**DELEGATED DECISION FRONT SHEET**

### **SCHOOL ZONES 2011/2012 – YARM PRIMARY SCHOOL**

This report presents the results of the consultation exercise carried out to determine a public consensus for the introduction of a School Zone at Yarm Primary School.

For information  
 Job No  
**125435-61**  
 Drawing No  
**C.950.G.007**  
 Issue  
**P3**

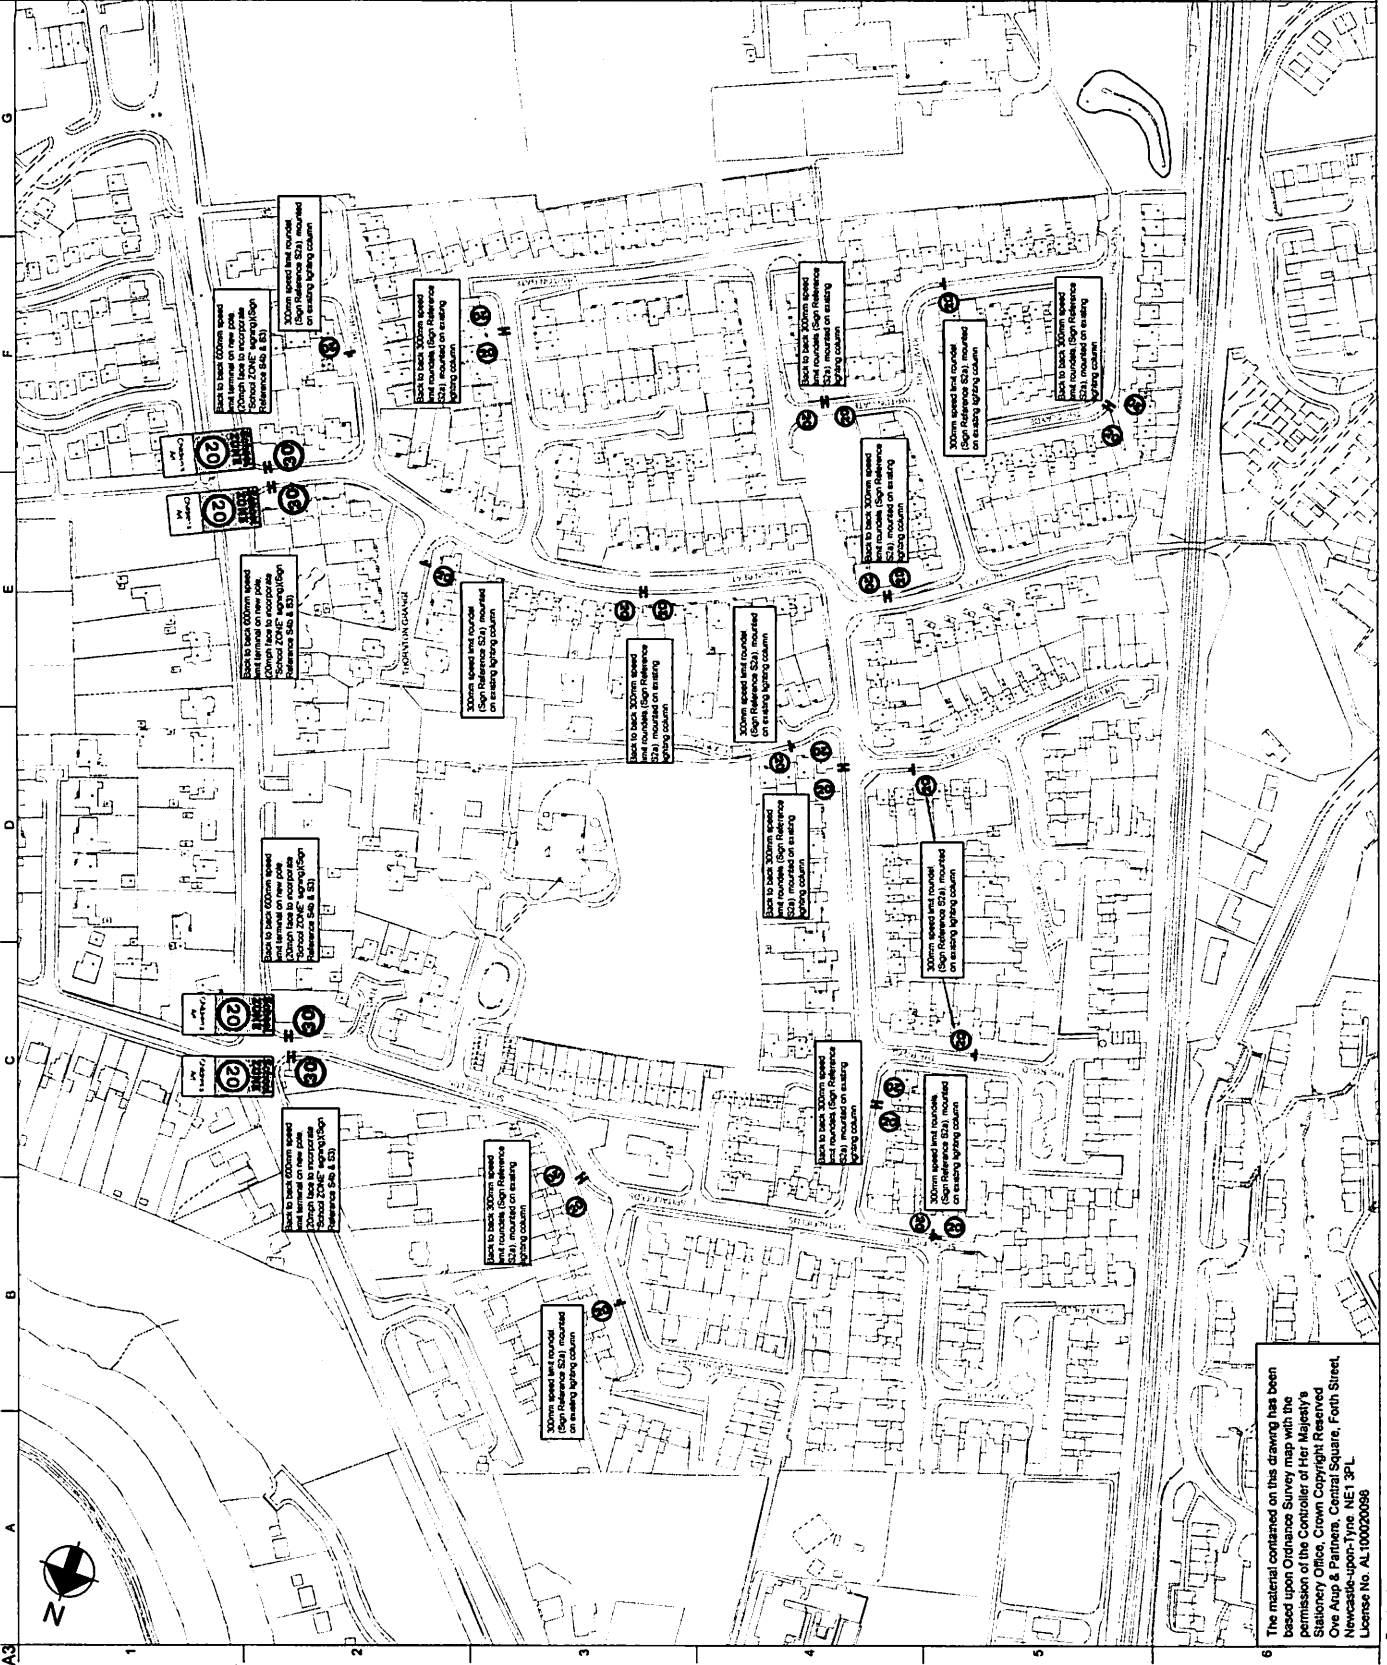
18. The responses show that many local residents had concerns regarding the installation of road humps on The Larun Beat noting that a number of factors, including parked cars and congestion at school start and finish times, already maintain vehicle speeds at low levels.

25. In addition to the concerns raised regarding the road humps, many residents responded with objections regarding the number of signs proposed advising drivers of the 20mph speed limit.

5. Road humps may result in irritating and aggravating drivers which is not conducive to safe driving.	See response to point 4.
6. Appearance and amount of signs a concern as it will look cluttered / littering an attractive estate with 49 new signs / signs and road humps will be an eyesore / signs are a visual hazard	The number and location of signs informing all users of the 20mph speed limit is governed by the Traffic Signs Manual published by the Department for Transport. The proposed layout is in accordance with the requirements of the

12. 4 humps is too many	See response to point 4.
13. Concern for the effect road humps have on parking	See response to point 4.
14. Speed humps at two entrances but not on the main entrance	Road humps were initially proposed on sections of the Larun Beat where vehicles

24. One of the speed humps is on a hill – this will cause problems in icy conditions / increased risk of skidding and losing control of the vehicle in icy conditions	See response to point 4.

24. The results in Table 2 indicate that average vehicle speeds are approximate to 24 mph at three of the four surveyed locations. Even West of Limpton Gate (southbound) the average speed is only 1.6mph above this 24mph threshold. It is therefore proposed that the traffic calming measures are removed from the scheme. A speed survey will be repeated one year after introduction of the scheme to monitor the effectiveness of the School Zone signs alone in reducing vehicular speeds to comply with the speed limit.

27. We therefore propose to alter the scheme by removing the humps and reviewing the sign layout. The amended scheme is shown on the attached Drawing C.950.G.007a and is as described below:

- ❖ A full-time 20mph speed limit to be introduced over The Larun Beat, Spitalfields, Spital Gate, Blackfriars, Clayton Lee, The Royd, Sideling Tails, The Brookes, The Slayde, Limpton Gate, Thornton Garth and The Rigg requiring the erection of terminal speed limit / 'School Zone' signing on four new posts at the junctions with Thirsk Road, plus repeater roundels to be fixed to existing lamp columns – exact number and location of signs to be confirmed. Road humps will not be provided.

additional traffic calming measures. The 4 proposed road humps have therefore been removed from the scheme.

29. Some residents also objected to the number of signs proposed to indicate the extent of the School Zone. The number of signs is governed by the Traffic Signs Manual, published by the Department for Transport and all signs have been placed in accordance with the criterion. However, when taking the scheme through to detailed design the number of signs will have been reassessed to see if any efficiencies can be made whilst maintaining the requirements of the TSM. The number of repeater signs has been reduced from 34 to 25 which is the absolute minimum while meeting the requirements of TSM.

<b>COMMENT</b>	<b>RESPONSE</b>
4. Speed bumps not necessary as speeding not a problem in the area.	Road humps were initially proposed on sections of the Larun Beat where vehicles have the greatest ability to gather speed. To enforce a 20mph it was considered necessary to apply measures, in line with other residential estates, on these routes to encourage compliance with the 20mph speed limit. However, feedback from residents indicated that road humps would not be necessary because despite the straight geometry of the route, other factors such as parked cars and vehicle congestion, already maintained low vehicle speeds. Consequently, a speed survey was undertaken and the results indicate that at three of the four survey locations, average vehicle speeds are 25mph or less. As a result, a decision has been taken not to proceed with the traffic calming measures.
